Access Compliance Report

Public Rights-of-Way

(Curb Ramps)

Intersection ID: 6218	Main Street: BEAM_LAKE_DR	Cross Street: PEACHWOOD_DR	Location: NW
ADA ID: 480738CCBB37	Ramp Type: PerpDiag	Initial Pass/Fail: Fail	Overall Compliance: No
Codes/Mitigation Info/Possible Solution		Field Measurements/Component Compliance	
Severity Score: 31.25

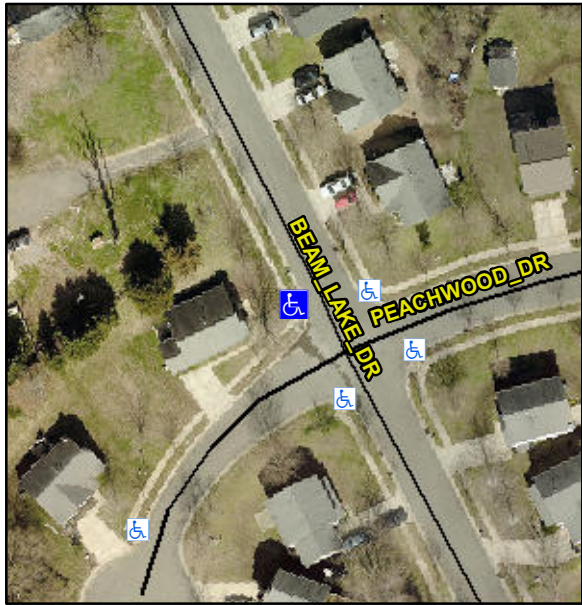
Compliance	Description	Data	Compliance	Description	Data
N/A	Ramp Length (in)	47.0	No	Ramp Slope (%)	10.0
No	Ramp Width (in)	32.0	No	Ramp XSlope (%)	2.6
N/A	Flare Type LT	N/A	N/A	Flare Type RT	N/A
N/A	Flare Slope LT (%)	N/A	N/A	Flare Slope RT (%)	N/A
N/A	Flare Traversable LT?	N/A	N/A	Flare Traversable RT?	N/A
N/A	Landing Length (in)	N/A	N/A	DWS Provided?	N/A
N/A	Landing Width (in)	N/A	N/A	DWS Contrast?	N/A
N/A	Landing Slope (%)	N/A	N/A	DWS Length (in)	N/A
N/A	Landing X Slope (%)	N/A	N/A	DWS Full Width?	N/A
N/A	Landing Curb? (Y/N)	N/A	N/A	DWS Offset (in)	N/A
N/A	Shared Landing?	N/A			
N/A	Gutter Ponding?	N/A	N/A	Gutter Slope (%)	N/A
N/A	Gutter Lip Ht (in)	N/A	N/A	Gutter X Slope (%)	N/A
N/A	Painted X Walk1?	No	N/A	Painted X Walk2?	No
	X Walk 1 Direction	To S		X Walk 2 Direction	To E
N/A	X Walk 1 Width (in)	N/A	N/A	X Walk 2 Width (in)	N/A
	X Walk 1 Slope (%)	3.5		X Walk 2 Slope (%)	2.3
	X Walk 1 X Slope (%)	0.4		X Walk 2 X Slope (%)	3.6

N/A	Ramp inside XWalk1?	N/A	N/A	Ramp inside XWalk2?	N/A
	Road Slope (%)	1.6	N/A	Clear Space?	N/A
	Road X Slope (%)	0.2	N/A	Clear Space to XWalk (in)	N/A
N/A	Any Obstructions?	N/A	N/A	Storm Grate/Utility Hazard?	N/A
	Obstruction Type			Storm Grate/Utility Type	
		N/A			N/A
			Yes	Surface Condition? (G/P)	Good

Possible Solutions:			
	Remove & Replace Curb Ramp With Two New Directional Ramps or Equivalent.			
	Surveyor Notes:			
	N/A			
	PROW/ADA:			
	Not Found, R304.5.1, R304.2.2, R304.5.3			
	Total Cost:		\$	3200.00
